Access Compliance Report

Public Rights-of-Way

(Curb Ramps)

Intersection ID: 31278	Main Street: W_MALLARD_CREEK_CHURCH_RD	Cross Street: MALLARD_GLEN_DR	Location: E
ADA ID: F4B74D1099F6	Ramp Type: PerpDiag	Initial Pass/Fail: Fail	Overall Compliance: No
		Severity Score: 26.25

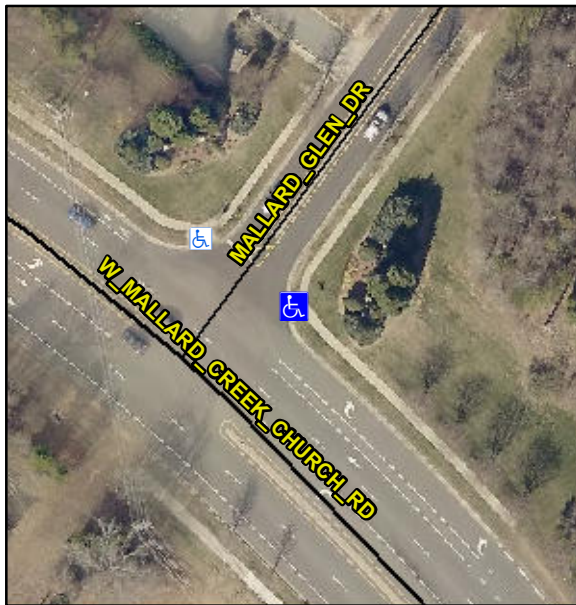
R304.2.2, R304.5.3

Compliance	Description	Data	Compliance	Description	Data
N/A	Ramp Length (in)	60.0	No	Ramp Slope (%)	14.0
Yes	Ramp Width (in)	48.0	No	Ramp XSlope (%)	3.0
N/A	Flare Type LT	N/A	N/A	Flare Type RT	N/A
N/A	Flare Slope LT (%)	N/A	N/A	Flare Slope RT (%)	N/A
N/A	Flare Traversable LT?	N/A	N/A	Flare Traversable RT?	N/A
N/A	Landing Length (in)	N/A	N/A	DWS Provided?	N/A
N/A	Landing Width (in)	N/A	N/A	DWS Contrast?	N/A
N/A	Landing Slope (%)	N/A	N/A	DWS Length (in)	N/A
N/A	Landing X Slope (%)	N/A	N/A	DWS Full Width?	N/A
N/A	Landing Curb? (Y/N)	N/A	N/A	DWS Offset (in)	N/A
N/A	Shared Landing?	N/A			
N/A	Gutter Ponding?	N/A	N/A	Gutter Slope (%)	N/A
N/A	Gutter Lip Ht (in)	N/A	N/A	Gutter X Slope (%)	N/A
N/A	Painted X Walk1?	No	N/A	Painted X Walk2?	No
	X Walk 1 Direction	To NW		X Walk 2 Direction	To SW
N/A	X Walk 1 Width (in)	N/A	N/A	X Walk 2 Width (in)	N/A
	X Walk 1 Slope (%)	1.4		X Walk 2 Slope (%)	3.0
	X Walk 1 X Slope (%)	3.4		X Walk 2 X Slope (%)	3.0

Remove & Replace Curb Ramp With Two New Directional Ramps or Equivalent.
